HISTORIC AND DESIGN REVIEW COMMISSION

January 18, 2017 Agenda Item No: 20

HDRC CASE NO:	2016-533		
ADDRESS:	608 DAWSON ST		
	610 DAWSON ST		
LEGAL DESCRIPTION:	NCB 569 (DAWSON PLACE), BLOCK 17 LOT 19		
	NCB 569 (DAWSON PLACE), BLOCK 17 LOT 20		
ZONING:	R-3,H		
CITY COUNCIL DIST.:	2		
DISTRICT:	Dignowity Hill Historic District		
APPLICANT:	PPLICANT: Carlos Rodriguez/Brightstar Development, LLC		
OWNER:	Brightstar Development, LLC		
TYPE OF WORK:	Revisions to previously approval for new construction

PHOTOS SUBMITTED BY APPLICANT 1/11/17 IN RESPONSE TO STAFF'S COMMENTS - PAIRED WINDOWS WITH MIDDLE TRIM

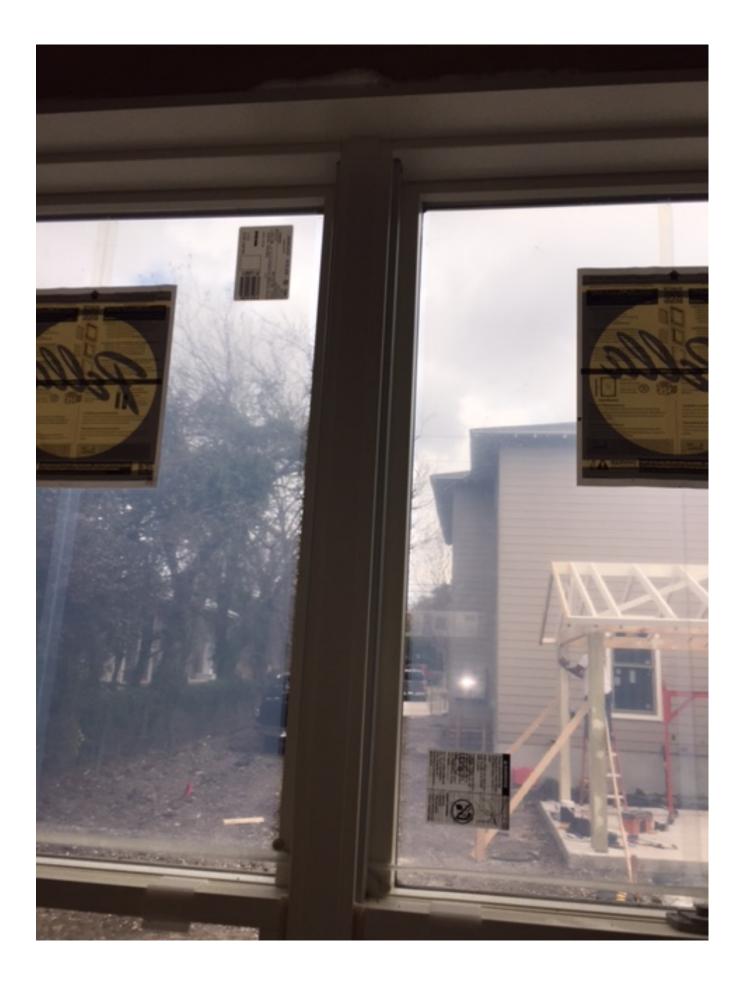
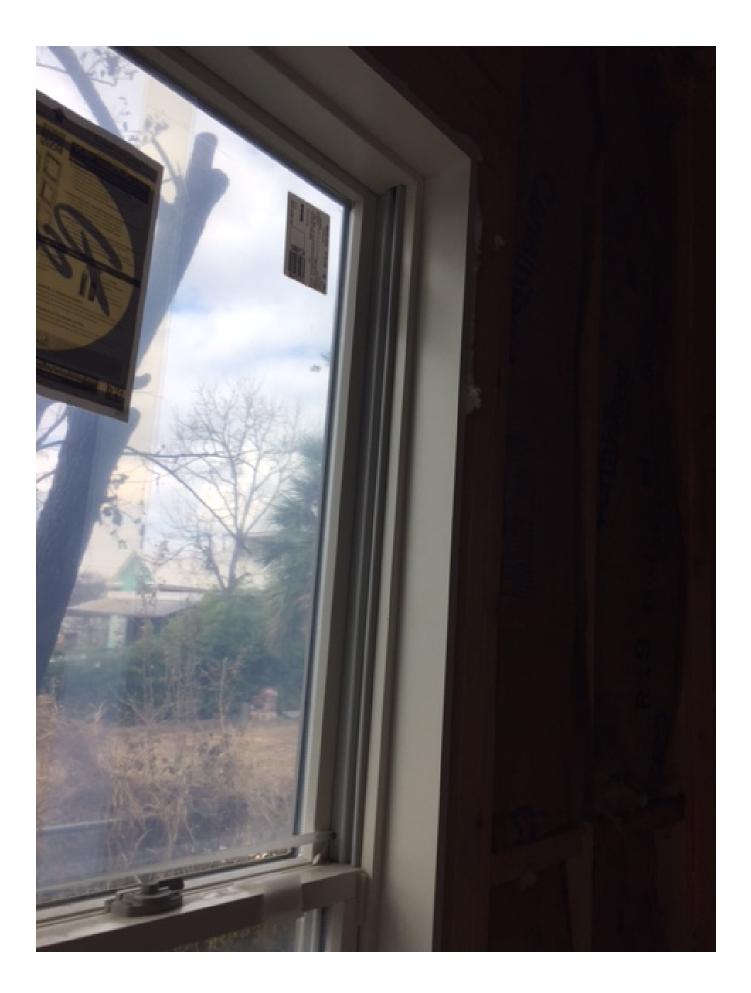
- 1. That the paired windows be separated by a wood trim as noted in finding d.
- 2. That the all new windows be made of wood as noted in finding d.
- 3. That the 2 aluminum clad fixed windows include dividing lights as noted in finding e.
